SST 2XLR + SST 2SWITCH PCB'S

4B SST SCHEMATIC

INPUT - MAIN - POWER AMP

FILE: 4B-SST-SCH-2A PART No: DATE: AUG 5, 04 DWG BY: ST REV: 2A

SST-4B78-PSB

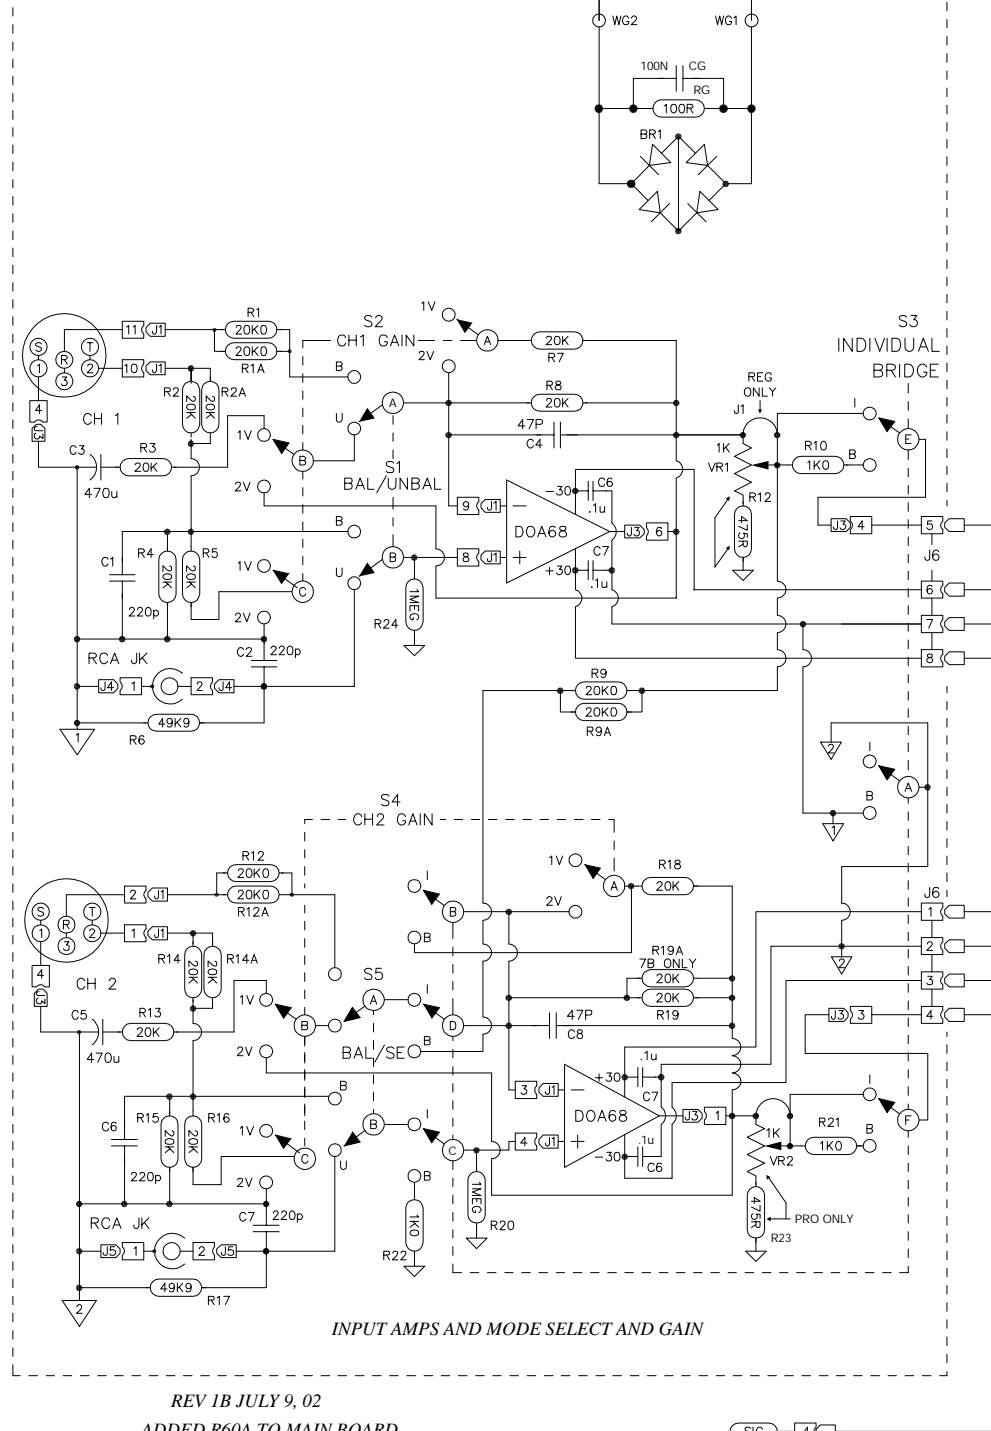
REV 1B JULY 9, 02

ADDED R60A TO MAIN BOARD

REV 1A JUNE 24, 02

CHANGED R16, 33, 34 + 36 TO 301R ECO 616

Rev 1E change C26, C8 to 10N and R44 to 30K1 on SSB

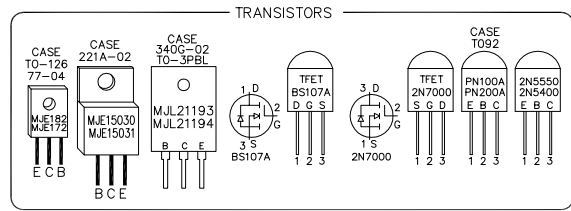
Rev 2 - ADD 4081 TO MAIN BOARD

SST- MB rev 7
no bs107 or 2n700
